RE: OEP/DG2E/Gas Branch 3
Mountain Valley Pipeline, LLC
Docket No. CP25-60-000
§ 375.308(x)
Response to Environmental Information Request 3

**Mountain Valley Pipeline, LLC
MVP Southgate Amendment Project
Docket No. CP25-60-000**

**Responses to FERC Office of Energy Projects Environmental Information Request 3
Dated July 25, 2025**

DRAWING NO.
MVP-SG-43A

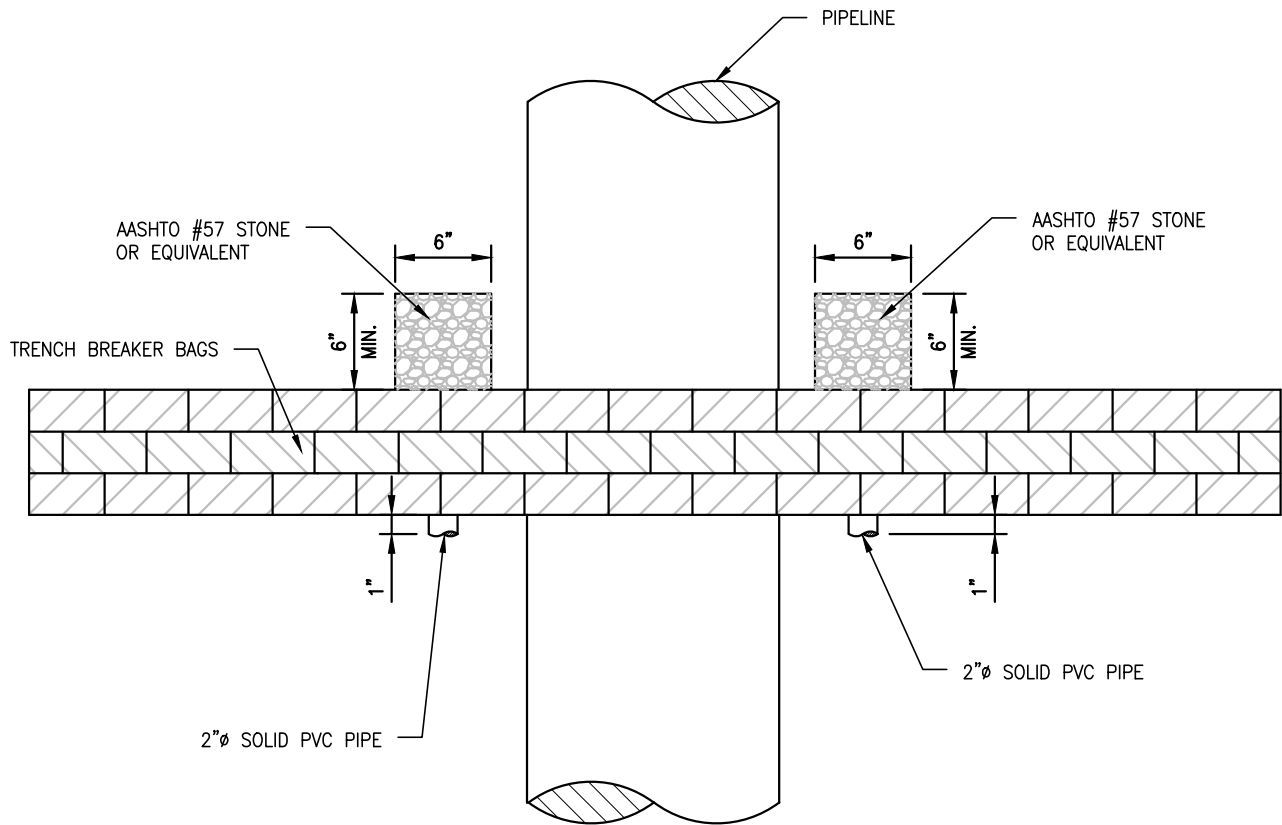
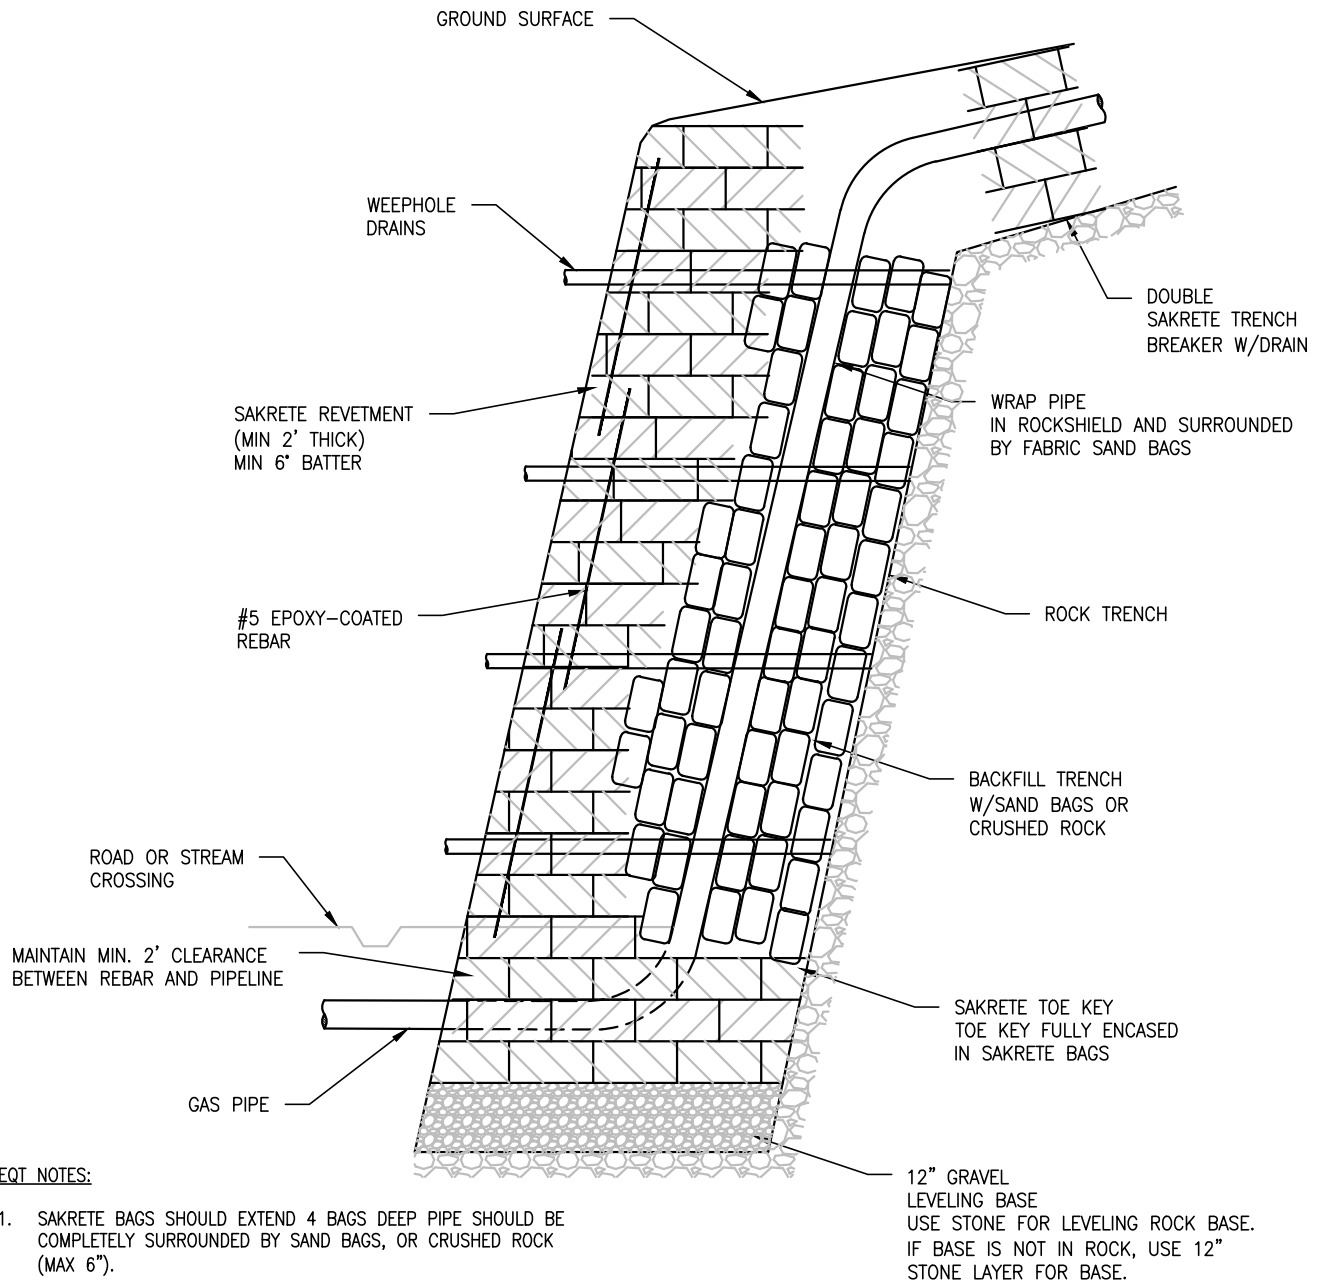
Regarding Mountain Valley’s Landslide Mitigation Report, Appendix A, clarify if the entire appendix (all entries) is completely new or revised from the previously approved version of the plan.

- **Trench Breaker Pass-through Drain (MVP-SG-43A/B):** The pass-through trench breaker drain is intended to prevent the buildup of water behind trench breakers, which could saturate the slope and cause a slide. These pass-through drains will be installed on the same slopes as the trench breaker daylight drains and will provide a way for groundwater to reach the daylight drains and ultimately be pulled to the surface. The trench breaker pass-through drains will allow water to pass through the trench breaker using two 2" PVC pipes, which will be placed near the bottom of the trench breaker.

Figure 7: Sandy River HDD Barriers

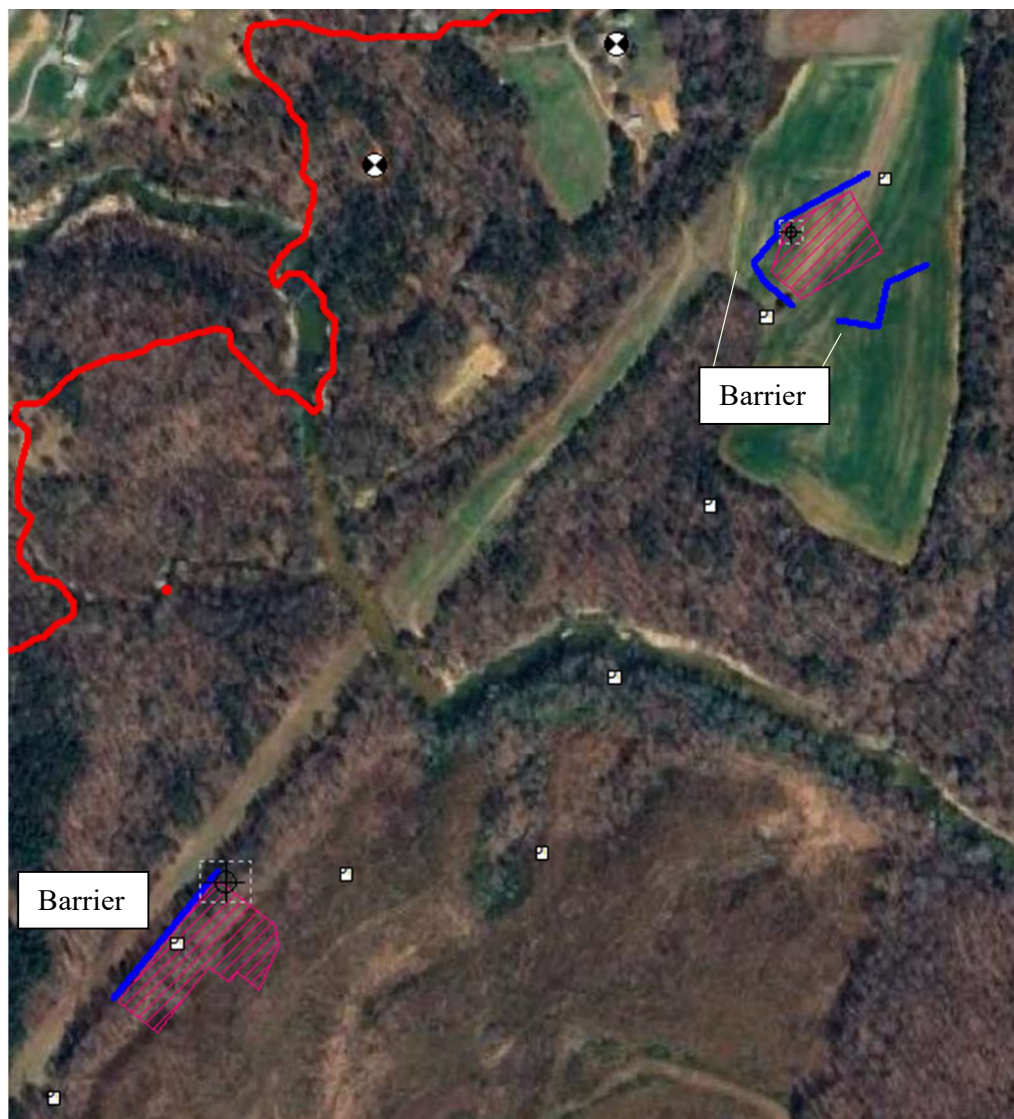
Some of the redline plans are missing appendices. Provide updated redline plans that include the appendices for:

- a. Landslide Mitigation Report is missing Appendix B;
- b. Nighttime Construction Noise Management Plan is missing Appendix A; and
- c. Public, Stakeholder, and Agency Participation Plan is missing Appendix B.

- b. Appendix A to the Nighttime Construction Noise Management Plan (Horizontal Directional Drilling Nighttime Construction Noise Evaluation, was originally filed as Appendix 9D to Resource Report 9 in Mountain Valley's February 3, 2025 Application). These were new evaluations which were completed specifically for the Amendment Project. These are included to the redline copy of the Nighttime Construction Noise Management Plan and is provided as Attachment 2 of this Environmental Information Request response.

Figure 11 and Figure 12 show examples of possible enclosure layouts and Figure 7 shows a close-up view of the HDD entry and exit barriers.
